#### DRAINAGE INFORMATION SHEET

RE: DRAINAGE PLAN FOR PHASE II - 7710 CENTRAL AVENUE, SE

(K-19/D91) ENGINEER'S STAMP DATED MAY 24, 1989

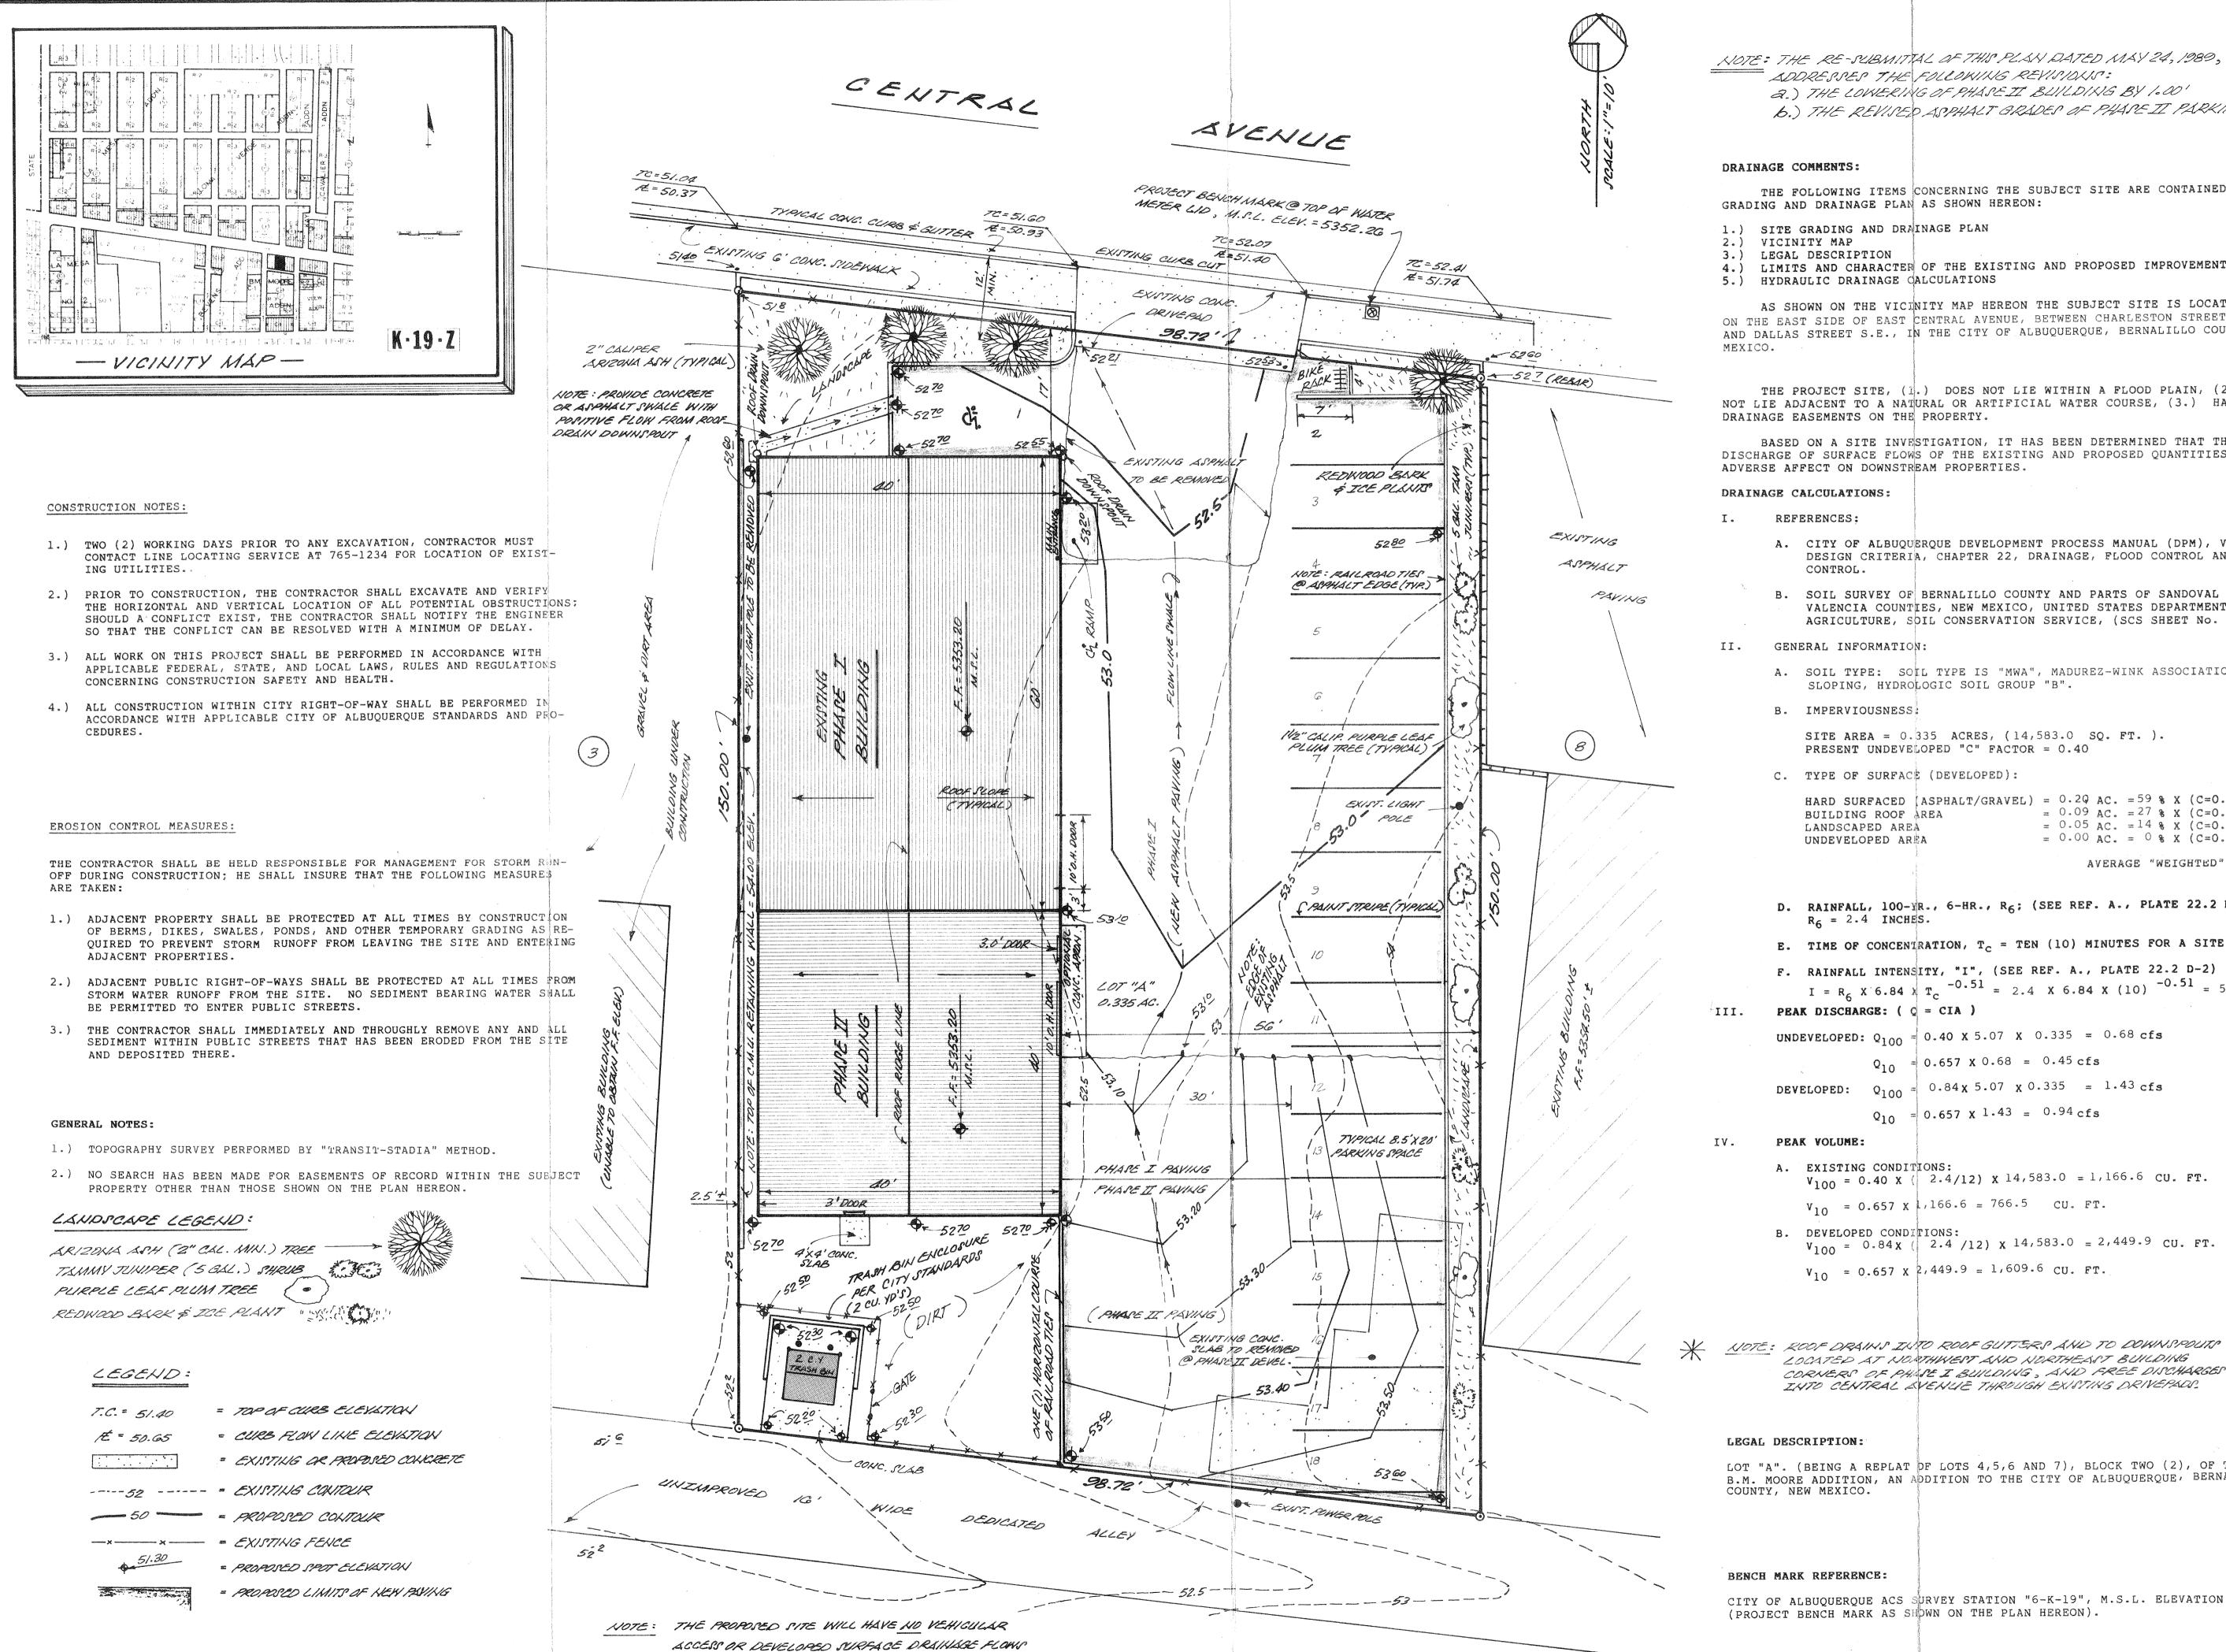
Based on the information provided on your submittal of May 25, 1989, the above referenced plan is approved for Building Permit.

Please attach a copy of this plan to the construction sets prior to sign-off by Hydrology.
